# ADDENDUM 2

**Gouverneur Central School District**  
**Reconstruction**  
**Senior High School**  
**SED Control No. 51-11-01-06-0-007-011**

**March 8, 2019**

**ADD-2**

DATE	03/05/19
BY	AKM/FJR
PROJ NO.	1537
SKETCH	ADDENDUM 2
<b>AD-E2SS</b>	
SS-E001 REF. DWG.: SS-E601

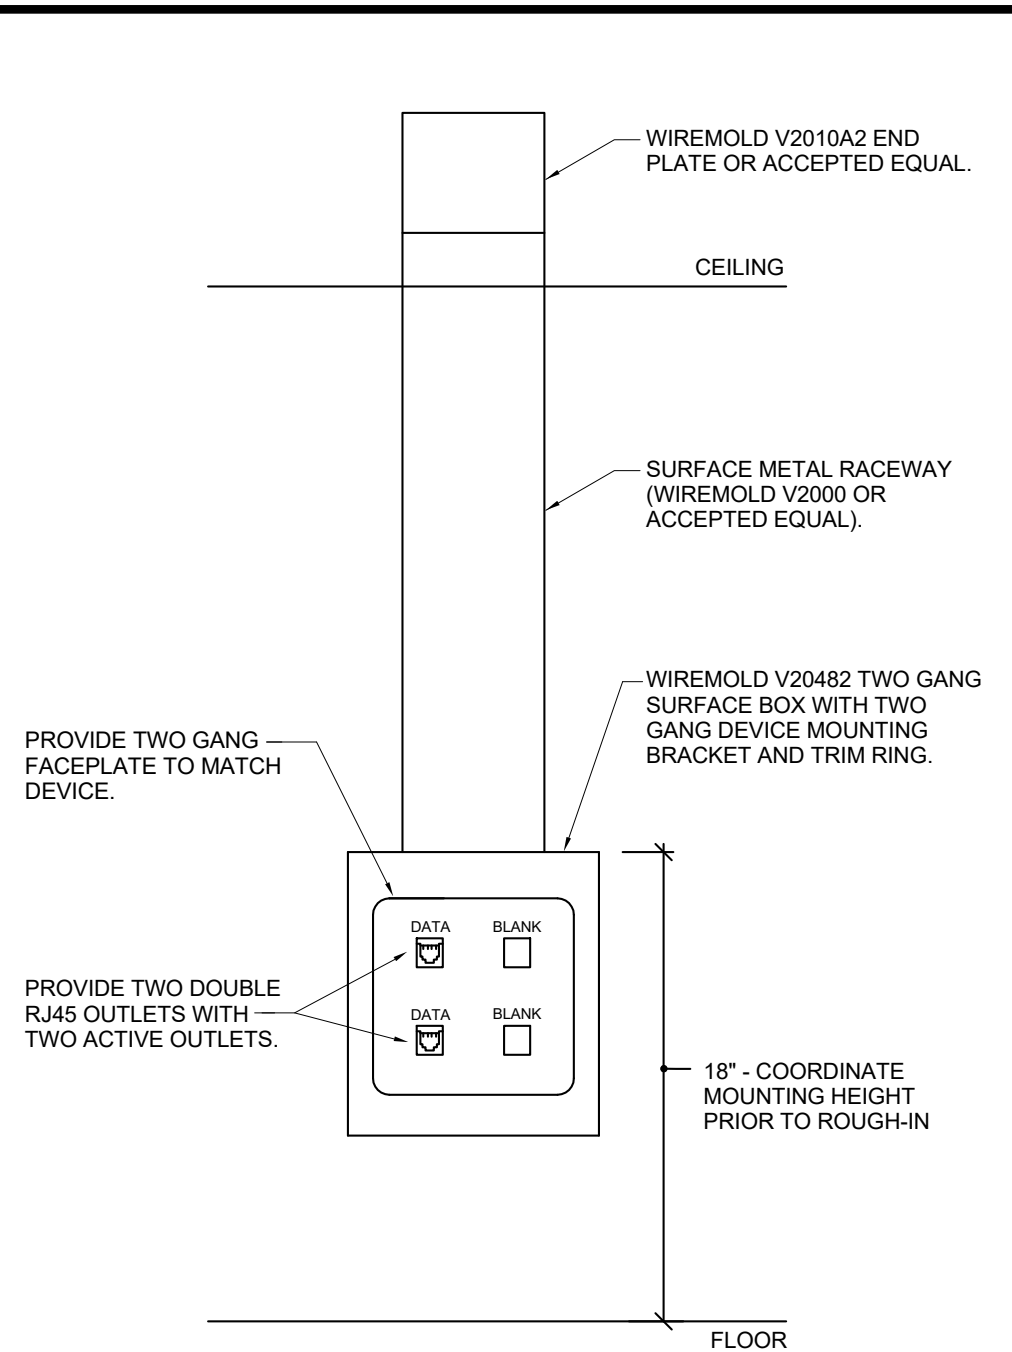
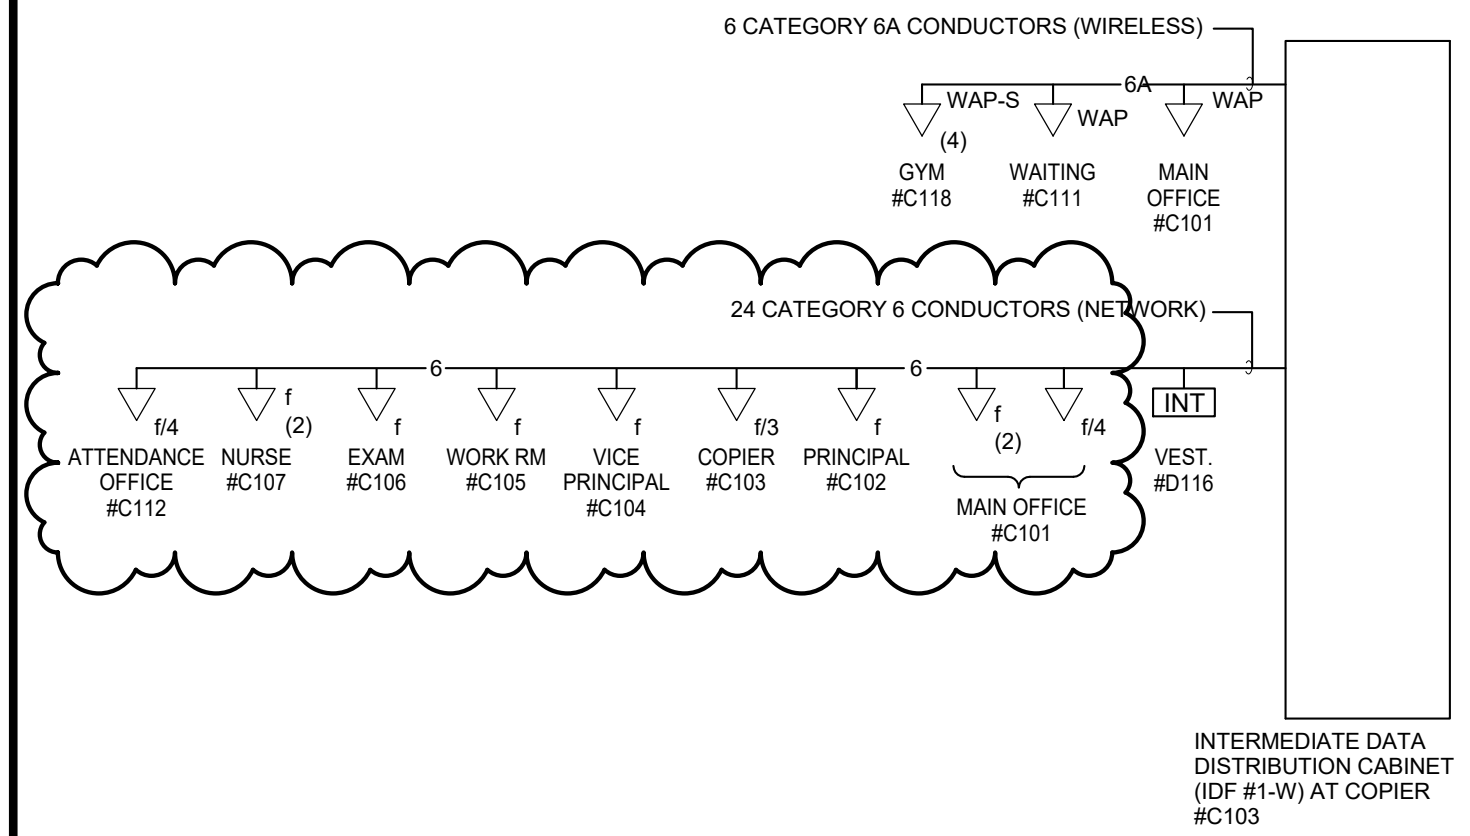
- ITEM 9. DRAWING SS-E001, SYMBOL LISTS, SCHEDULES & DETAILS
- A. **ADD** Computer/Data Workstation Outlet - Type "f," "f/3," "f/4," as indicated on attached Sketch AD-E2SS.

- A. Refer to "Data Riser Diagram," **PROVIDE** additions and revisions as indicated on attached Sketch AD-E2SS.

**NOTE:**  
 A. AT OUTLETS NOTED f/3 PROVIDE THREE WIRED RJ45 OUTLETS;  
 AT OUTLETS NOTED f/4 PROVIDE FOUR WIRED RJ45 OUTLETS.
